re: Geotechnical Review - Preliminary SWMP Design
Phase 7 - Cardinal Creek Village
Old Montreal Road - Ottawa

file: PG1796-MEMO.211

As requested, Paterson Group (Paterson) prepared the current memorandum to provide a geotechnical review of the preliminary design drawings for the proposed stormwater management pond (SWMP) to be located within Phase 7 of the Cardinal Creek Village development in the City of Ottawa. The following sections detail our review findings and recommendations.

Title: **BEDROCK CONTOUR PLAN**

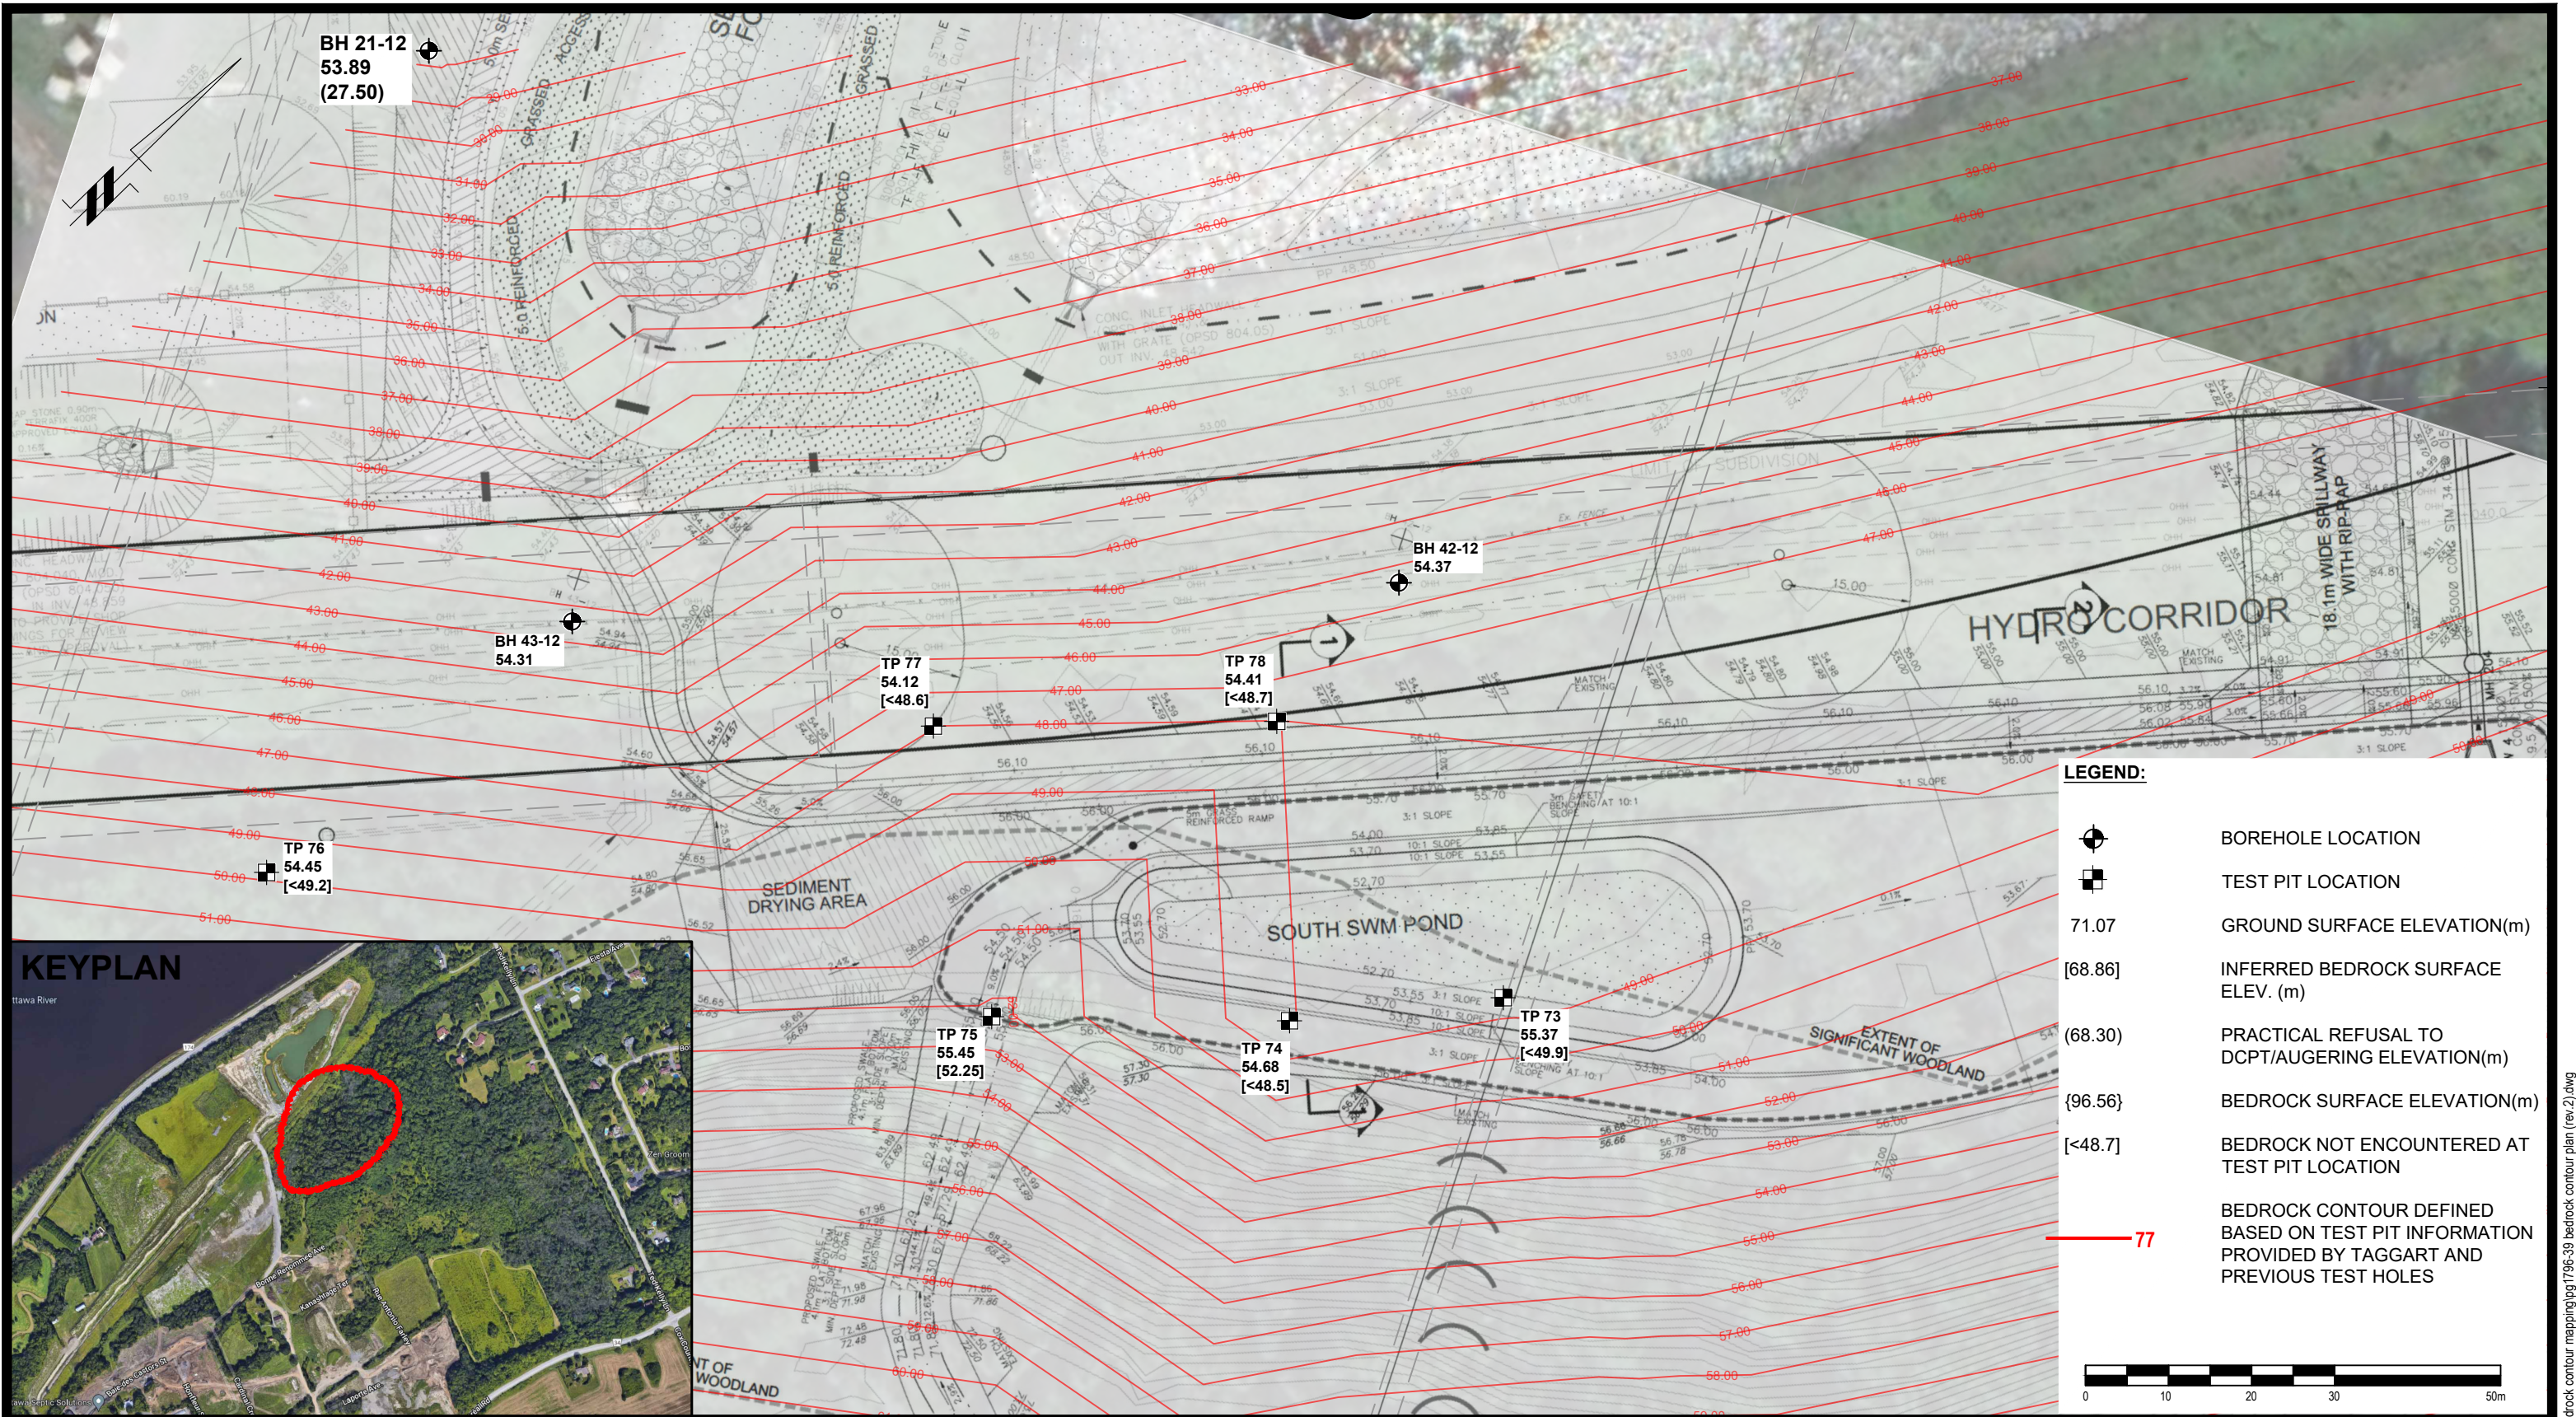
Existing boreholes adjacent to the proposed pond location and bedrock contour mapping completed at the proposed pond location indicate the presence of a silty clay deposit overlaying bedrock. The bedrock surface at the location of the proposed pond is expected to fluctuate between an elevation of 52 to 42 m based on surrounding boreholes. It is important to note that the bedrock drops more than 300 m from the south end of the subject site to the north end. Reference should be made to Drawing PG1796-45 - bedrock contour plan attached to the current memorandum.

It is expected that the overburden within the footprint of the subject pond to consist mainly of silty clay deposit including the bottom of the pond and the excavation side slopes. However, if bedrock is encountered within the side slopes or the bottom of the pond, a clay liner may be required depending on the field observations of the water infiltration during excavation. The clay liner should be 300 mm thick of workable, dry brown silty clay and compacted to a minimum of 95% SPMDD with a sheepsfoot roller. Alternatively, an HDPE clay liner may be used on the side slopes. Further details will be discussed upon receiving the finalized SWMP design drawings.
